DOE-0017-03

**TRANSMITTAL OF THE DRAFT INTEGRATED ENVIRONMENTAL MONITORING PLAN,  
REVISION 3**

**SUMMARY TABLE OF PROPOSED TECHNICAL CHANGES TO THE  
INTEGRATED ENVIRONMENTAL MONITORING PLAN, REV. 3**

FIGURE A.1-2. LOCATIONS FOR SEMI-ANNUAL URANIUM AND NON-URANIUM MONITORING PROPERTY/PLUME BOUNDARY, SOUTH FIELD, AND WASTE STORAGE AREA

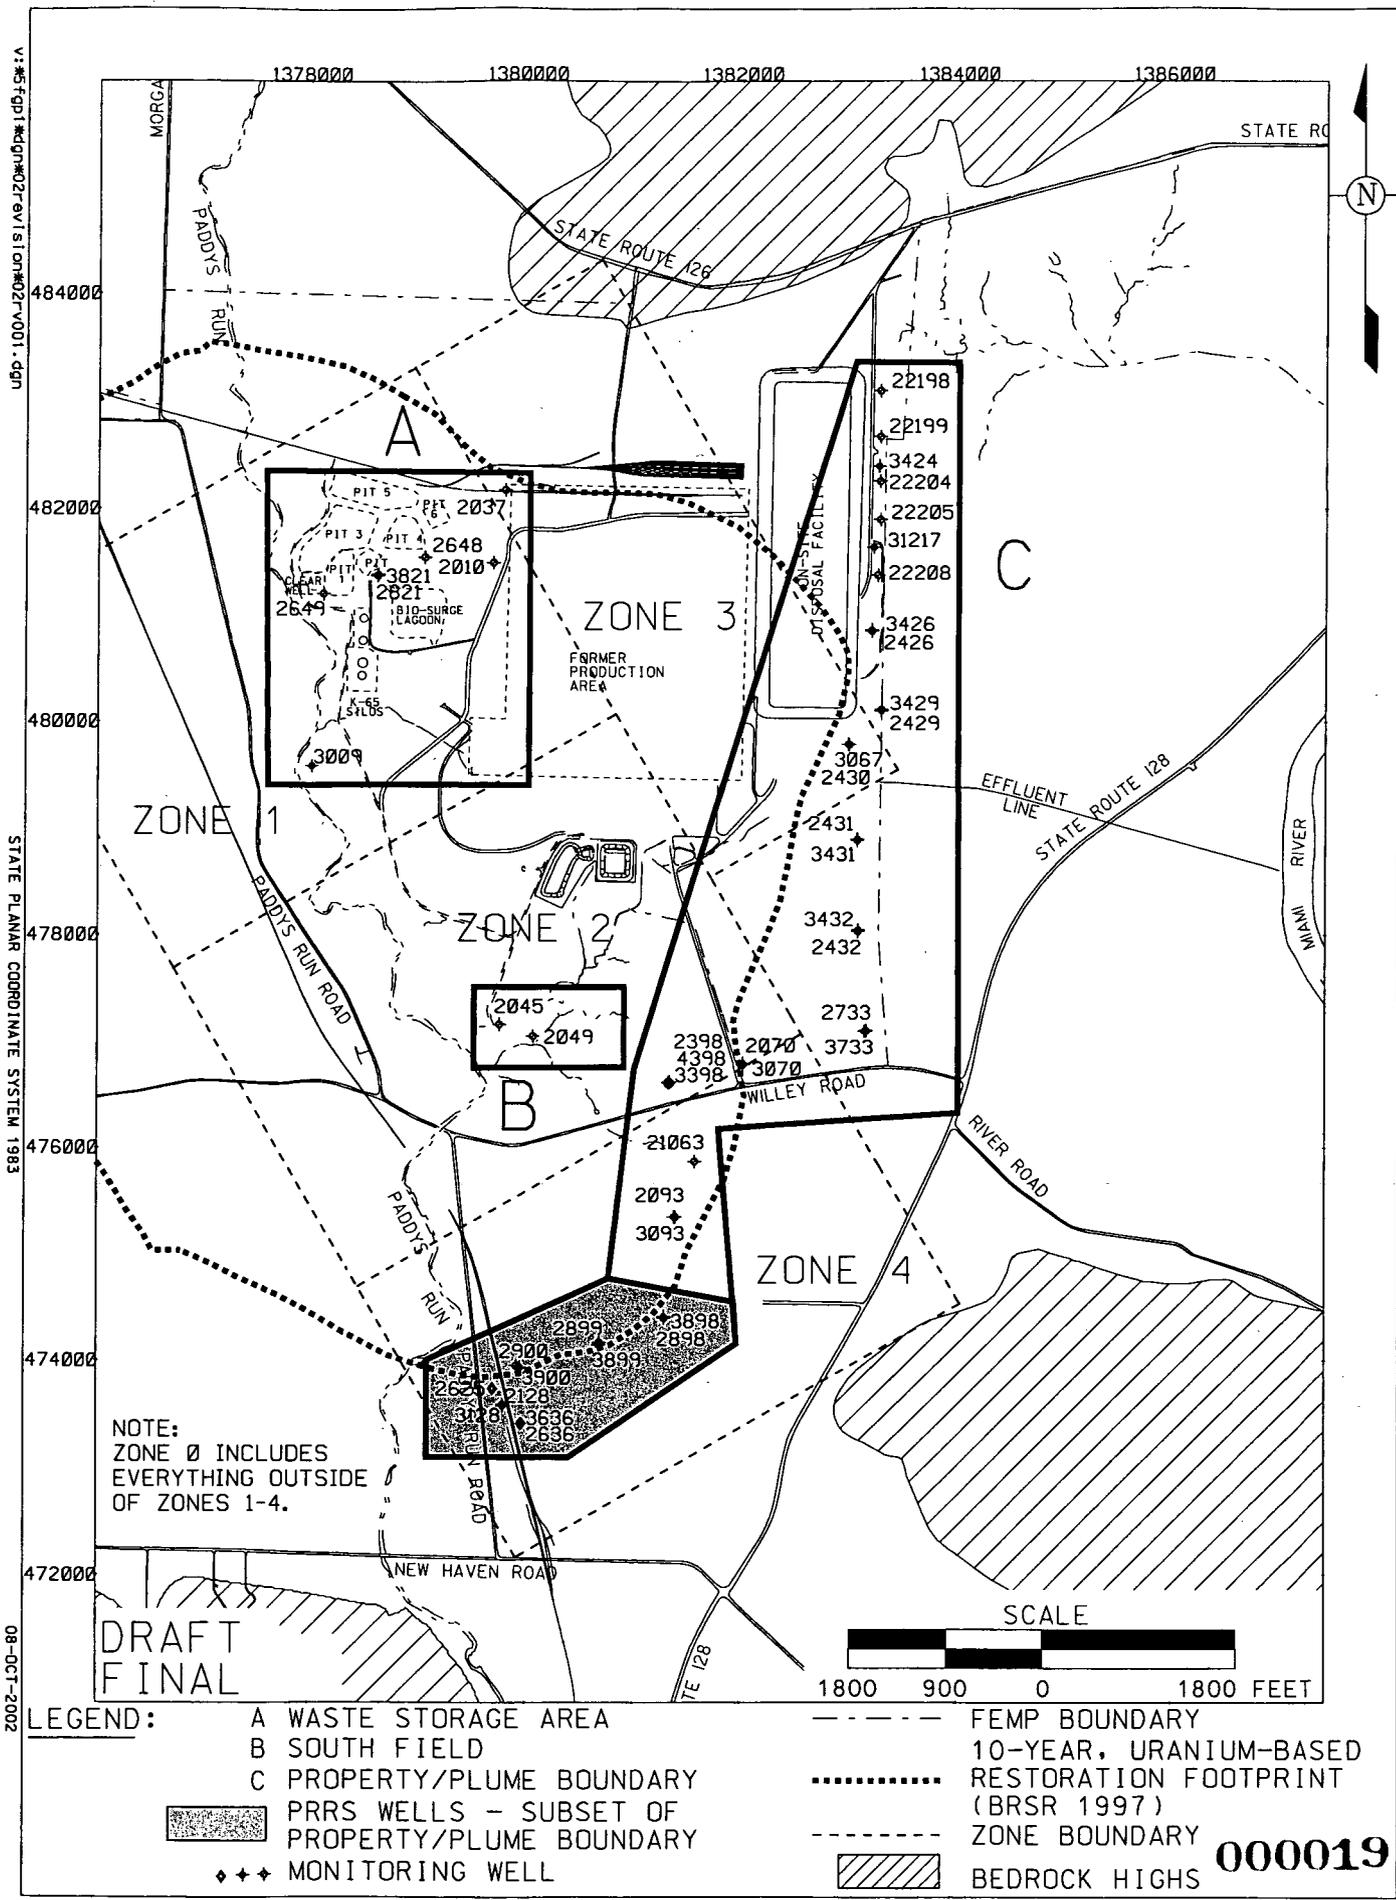
Section 3.5; Section 3.6.2; and Appendix A (and all associated tables)	Sample for area-specific FRL exceedances (i.e., total uranium and 13 additional constituents) on a semi-annual frequency at various locations including the property/plume boundary.	See Appendix A for detailed justification of changes. Two attachments to this table are also provided for comparative purposes. Attachment A.1 summarizes the recommended monitoring program and Attachment A.2 summarizes the program defined in the IEMP Revision 2 (2001-2002 program).

To facilitate the review, summaries of the monitoring requirements, including constituents and wells for each associated sampling activity are presented for both the proposed and the current program in Attachments A.1 and A.2, respectively. The proposal acknowledges the five years worth of groundwater data that has been collected since 1997 under the IEMP, to identify which constituents need to be analyzed more frequently (semi-annual cycle) and which can be captured by the five-year total FRL list requirement. The proposal also places a greater emphasis on uranium monitoring to track the success of the restoration effort, increasing the number of wells from 126 to 148. The five-year sampling is essentially the same under the current and proposed programs (i.e., all FRL constituents at all locations, chromium and dioxin exceptions noted in Appendix A). These attachments are in similar format to facilitate comparison of the existing and proposed sampling activities.
